DELEGATED APPLICATION REPORT

App Ref: PL/25/1506 Full planning permission

Address: 6-8 Stanshawe Rd, Reading, RG1 1PB

Proposal: Proposed change of use of the building to a 10 bedrooms HMO and proposed erection of a rear dormer extension.

Proposed Front Elevation

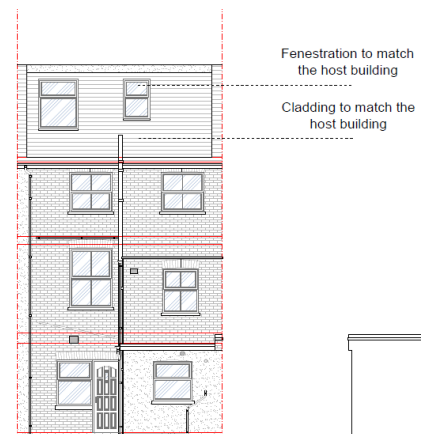
The size of the rear dormer conflicts with Reading Planning policy and design guidance, which should not be visually dominant or detract from its surroundings. The proposed dormer is excessive in scale spanning almost the full roof width, contrary to SPD guidance requiring dormers to be modest, set-in, and subordinate. There are no comparable large dormers on this terrace; the proposal would be visually dominant and harmful compares to buildings with smaller dormers set into the roof spaces of surrounding developments.

The existing hipped roof and chimney stack defines the character of the building as an end of terrace dwelling. The addition of the dormer and increased ridge height is not subservient or subordinate to the building and would have a negative impact of to the group of terraced houses. The dormer fails to comply with local design guidance requiring dormers to remain subordinate to the roofscape and detrimentally impacts the character of traditional terraced housing in Stanshawe Road contrary to Policy CR9e. No material specifications have been provided to confirm whether they would be in keeping with the character of the terraced building. The planning statement states that the roof would be '*sympathetic in relation to the adjacent building*' but does not specify which building it refers to. The proposed roof conversion and loss of the right side front door are considered to be unacceptable and fail to suitably preserve the character and appearance of the building, surrounding area and conservation area in accordance with Policies CC7, EN1 and EN3 is contrary to policies CC7, CR2, CR9e, CC2 and H9 and

11 Proposed Ground and first floor

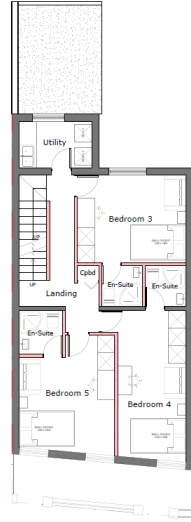
- The proposed plans show adequate showering/bathing, cooking facilities and food preparation areas.
 - Bedroom 2 (ground floor rear) – Has an inadequate means of escape. In the event of a fire the occupant would have to escape through the kitchen which is considered a high-risk room. This will need to be reviewed to ensure the occupant can escape in the opposite direction to where a fire is likely to be.

Plans show that Bedroom 3 is situated above the kitchen area on the ground floor, whilst the kitchen in the loft area is above bedroom 5. Policy H8 Residential conversions states *'There is no inappropriate stacking and location of rooms between units;'*

Bedroom 2 faces into the rear garden which is considered to lead to mutual overlooking and a lack of privacy from overlooking from the rear garden. It is also located next to the proposed external amenity dining table and communal seating area which is considered to result in a disturbance to future occupiers.

12 Proposed second and loft floor

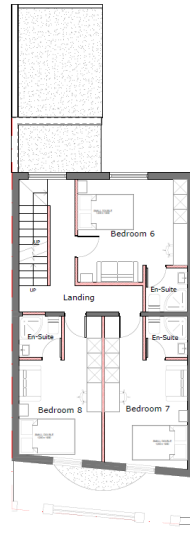
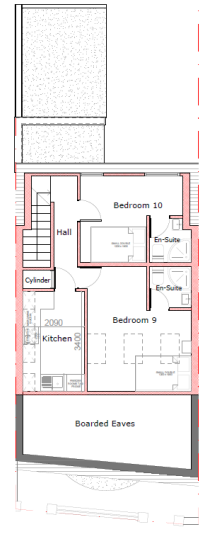
Bedroom 9 has 3 roof Velux windows however it is unclear whether there will be any outlook from this bedroom. It is also set into the roof eaves and no section of the living space has been provided to evidence that there would be sufficient head height and space standards. The submitted proposed plans do not show room dimensions (only a couple of small, isolated measurements and furniture sizes), and each sheet is marked "Do not scale for construction purposes."

Site visit photos of trees

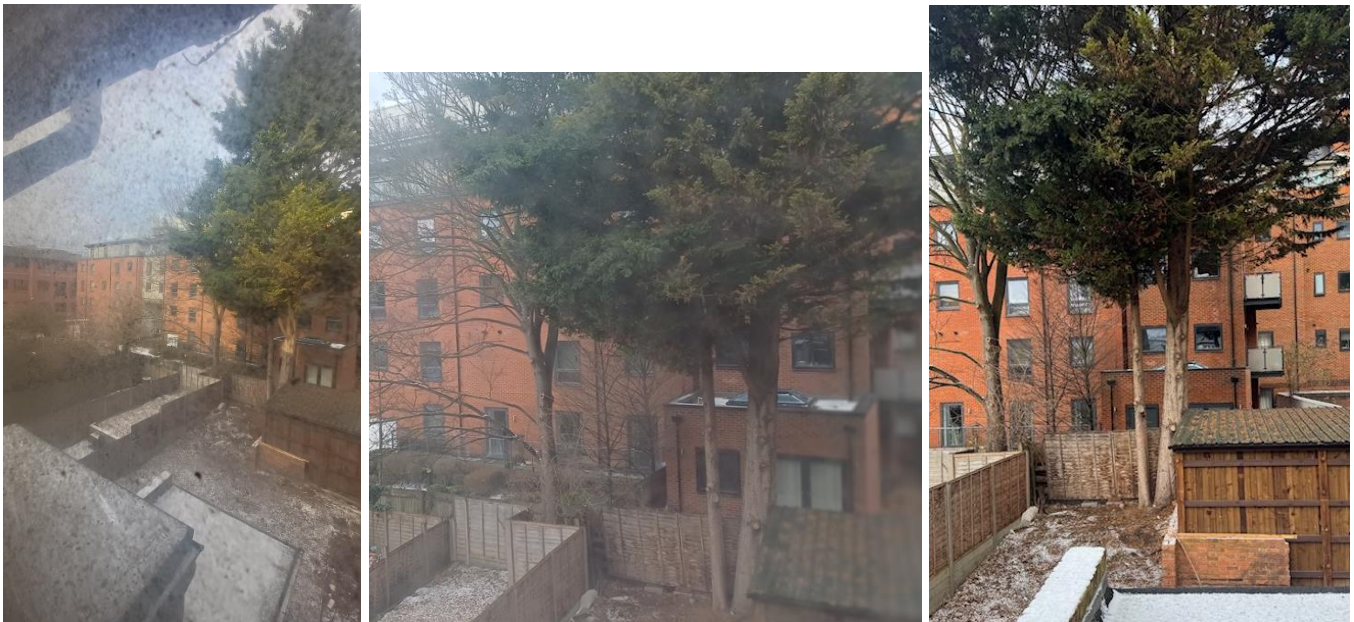
It was not possible to go in the rear garden however photos were taken from the rear windows of the building. No trees are indicated on the plans provided despite clear evidence of trees on site and the cycle stores are shown at the end of the garden which appear to overlap with an existing tree. There is a failure to demonstrate that the trees at the rear of the site would be protected during the refurbishment works and to provide additional information regarding any potential impact on any root protection areas. A cycle store is shown on the block plan in the same location as an existing tree. The trees should be shown on the proposed plans, with a tree survey to provide additional tree information. No hard and soft landscaping scheme has been provided to indicate the proposed flooring materials. The proposal is contrary to policies CC7 and EN14 or the Reading Local Plan 2019.
